ACCELERATED DISTRIBUTION DEMONSTRATION SYSTEM

REGULATORY INFORMATION DISTRIBUTION SYSTEM (RIDS)

SUBJECT: Responds to Questions 471.5 - 471.12 re App A exemption request for worker respiratory protection apparatus.

Re: St. Lucie Units 1 and 2
Docket Nos. 50-335 and 50-389
Request for Additional Information - 10 CFR 20
Appendix A Exemption Request for Worker Respiratory
Protection Apparatus (TAC Nos. 67138 and 67139)

FIGURE 1
SCOTT 631-TEDA-H CANISTER

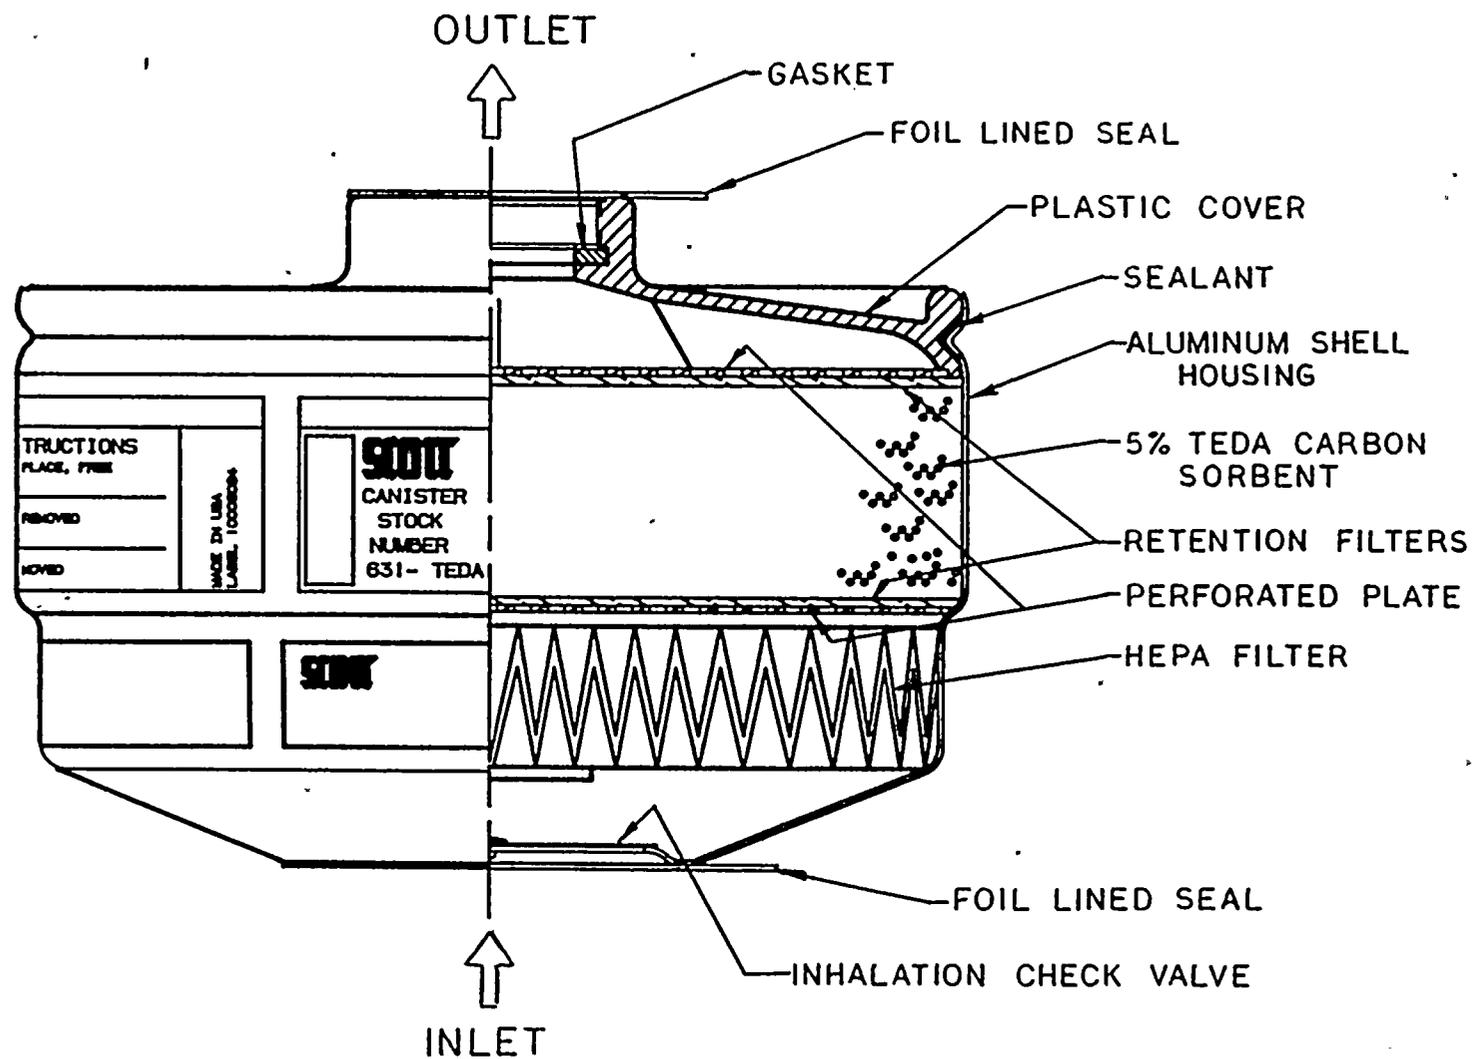
Provide a description of the SCOTT 631-TEDA-H canister including particulate filter, sorbent and percent TEDA. Address the question of the potential toxic hazard to the respirator user from inhalation of TEDA desorbed from the SCOTT 631-TEDA-H canister. Describe the criteria for use of these SCOTT canisters at St. Lucie (e.g., radioiodine concentration, canister labeling, prevention of canister reuse).

The 631-TEDA-H chin style gas mask canister is constructed using a 12 x 20 mesh (U. S. Sieve series) activated carbon, impregnated with 5% by weight triethylenediamine (TEDA), and a high efficiency particulate air (HEPA) filter. Figure 1, attached, depicts the canister construction.

The sorbent in the canister is batch certified to meet the ASTM D3803 and D4069 radioiodine performance requirements. The volume it occupies within the canister is 340 cc's.

The HEPA filter is a radially pleated high efficiency filter with greater than 99.97% removal efficiency against a 0.3 micrometer dioctylphthalate (DOP) aerosol. Canisters are 100% tested for DOP removal efficiency at the time of manufacture per NIOSH respirator certification requirements of 30 CFR Part 11.

FIGURE 2

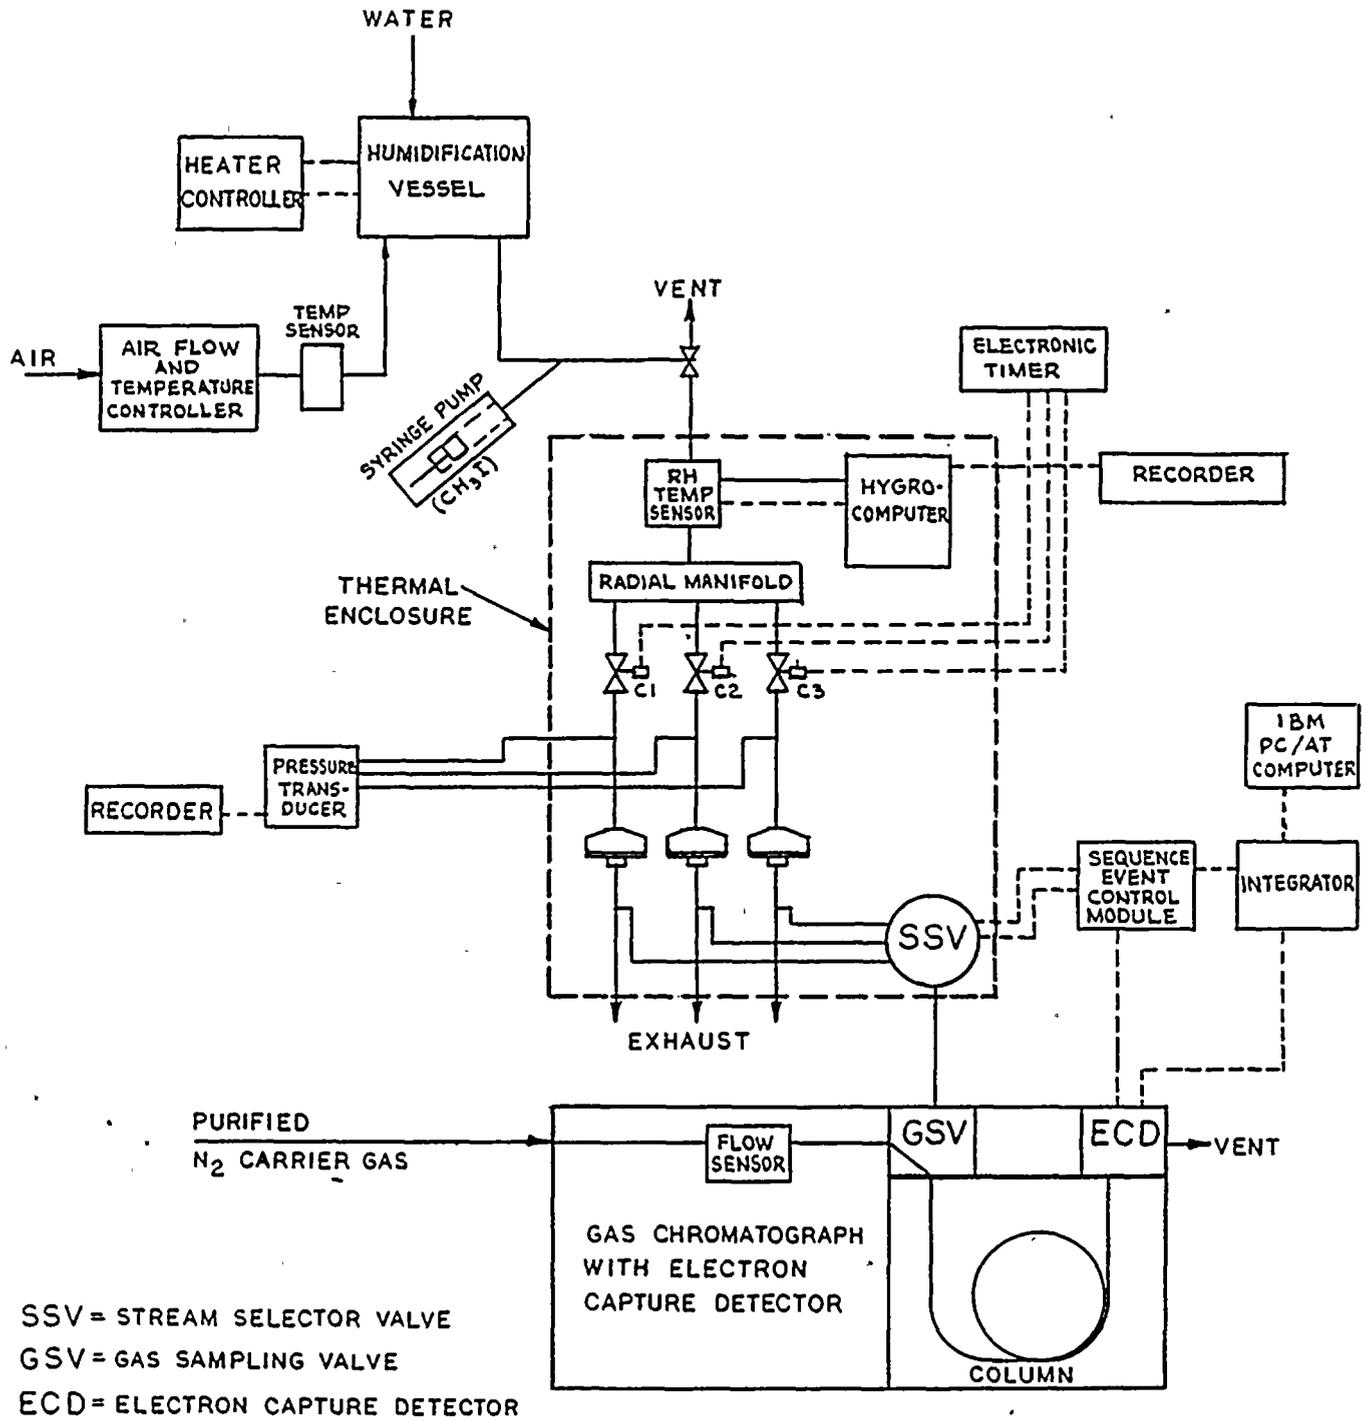
The FPL submittal includes tabular summaries of test conditions and test results provided by SCOTT for the SCOTT 631-TEDA-H canister but contains no other information on these tests or on the means for ensuring the reliability of the tests and test results. Provide a complete description and discussion of the test program (including apparatus used), the means for ensuring the reliability of the tests and the test results, and the basis for your acceptance of the test results. Include the complete name and address of the manufacturer (SCOTT) and the identification of the organization or group that actually performed the tests, if other than SCOTT.

A sketch depicting the test system used to determine the performance of the SCOTT 631-TEDA-H canisters against methyl iodide is shown in Figure 2. The primary

A modified Miller-Nelson (MN-301) airflow, temperature and humidity controller is employed for generation and control of the humidified air. The MN-301 unit delivers air at the desired temperature and flow rate to a humidity vessel. As the air passes through the water vapor laden headspace of the vessel, air-stream humidification and final air heating is accomplished. The temperature and humidity of the air stream is monitored using an optical dew point hygrometer. The hygrometer is located in the thermal enclosure for monitoring the air immediately prior to entering the canister inlet.

A syringe pump is used to generate the methyl iodide challenge concentrations of interest. Capability for generating challenge concentrations using this method was verified using a Miran 1A infrared analyzer and the gas chromatograph. Concentrations generated throughout the test program are verified using volumetric displacement measurement techniques and by use of the chromatograph.

Due to the high temperature and water vapor concentration of the airstream, in-line condensation in the transfer tubing was eminent unless appropriate measures were taken to prevent this condition. A heated enclosure was utilized to contain the canisters, the stream selector valve (which selected the appropriate air stream to be sampled) and the hygrometer. Temperature of the enclosure is set and controlled to the same temperature as the challenge airstream (i.e. 120°F or 100°F). Water vapor condensation is thereby eliminated. No temperature gradients were observed in the thermostated enclosure. A radial manifold is used

for distribution of the flow to the test canisters. Three solenoid valves controlled by an electronic timer unit allows for 192 lpm airflow delivery to each canister for 0.82 seconds and 0 lpm flow for 1.64 seconds (equivalent to a 64 liter minute volume). A pressure vs. time history of each flow segment is used to verify system pressure symmetry (i.e. flow), correct operation of the solenoid valves and "squareness" of the pulsed waveform. A fast response pressure transducer is used for these pressure measurements.

FIGURE 3

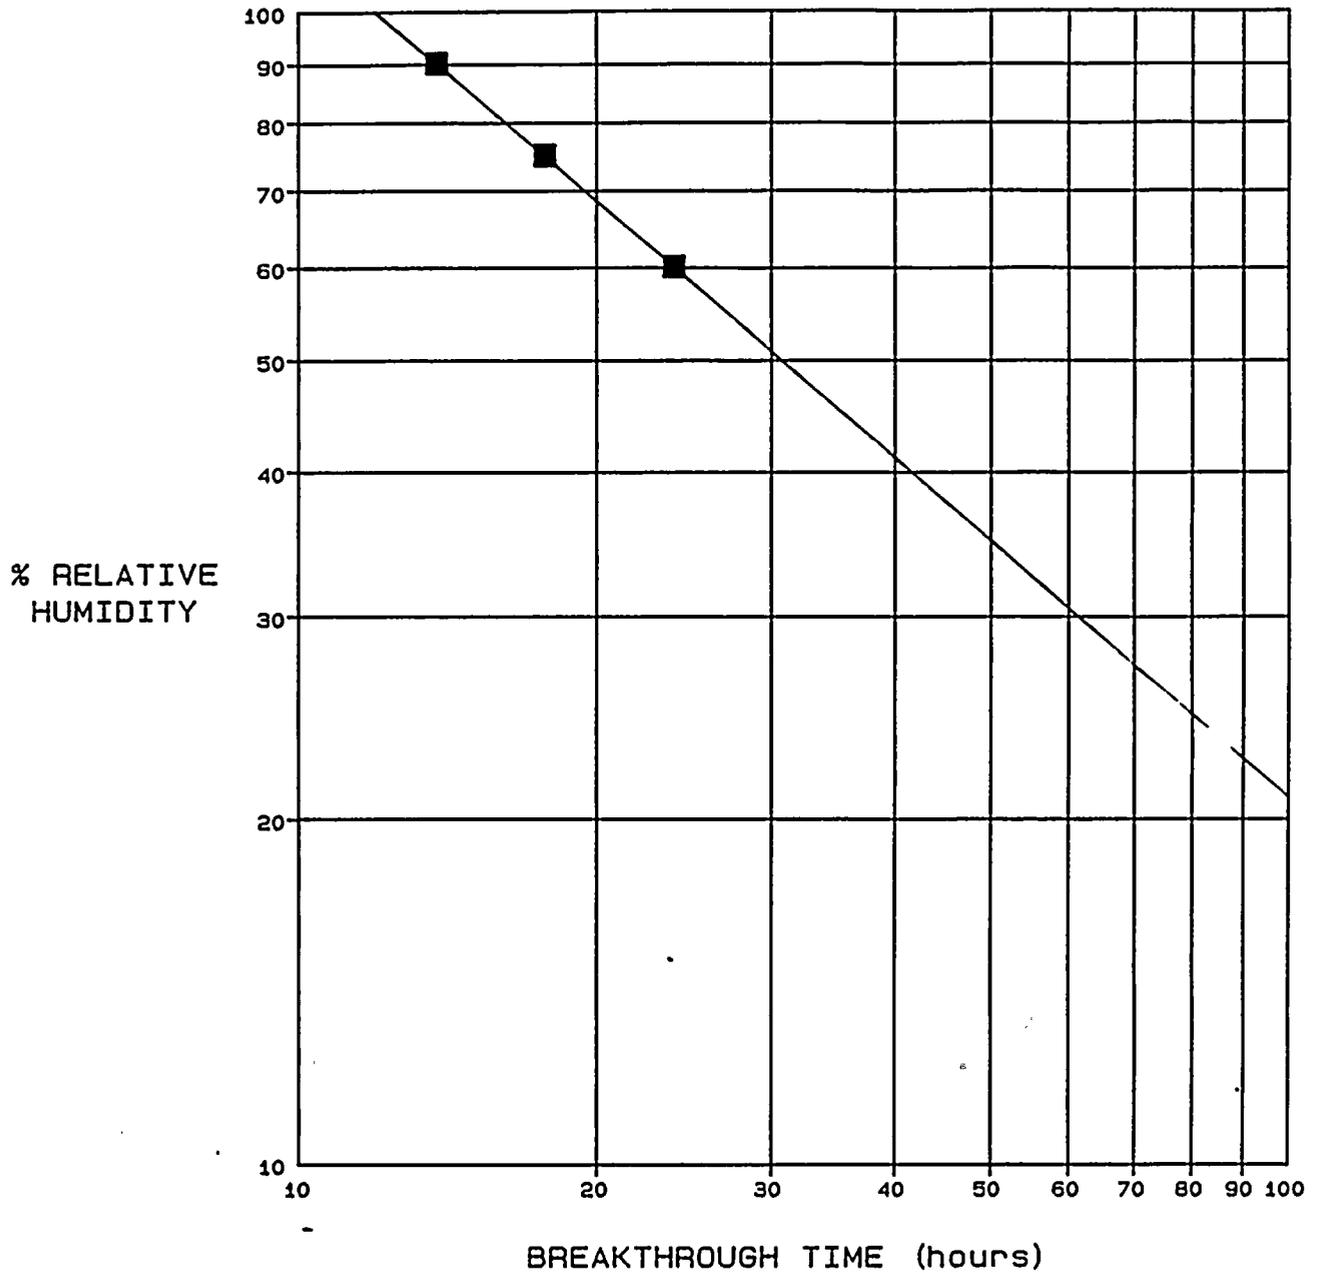
The FPL submittal states that the SCOTT canisters are not to be used in environments greater than 120°F but does not provide a limit on the relative humidity. Specify a limit on the relative humidity for canister use and provide the basis for this limit. Specify how compliance with the limits for temperature and humidity will be demonstrated.

The performance of the 631-TEDA-H canister has been characterized at various conditions which include 37.8°C/48.9°C temperatures and 60/90% relative humidity. The ability to extrapolate test results from one set of humidity conditions to another humidity level has been demonstrated (3). Using data at the 48.9°C temperature, a log-log plot of breakthrough time vs. % relative humidity has been prepared and is shown in Figure 3. Using a linear extrapolation, canister service life to a 1% methyl iodide penetration value is projected to be 12.0 hours.

Use of the 631-TEDA-H canister in a saturated air stream

at 48.9°C (120°F) should provide a nominal 12 hour duration to a 1% methyl iodide penetration.
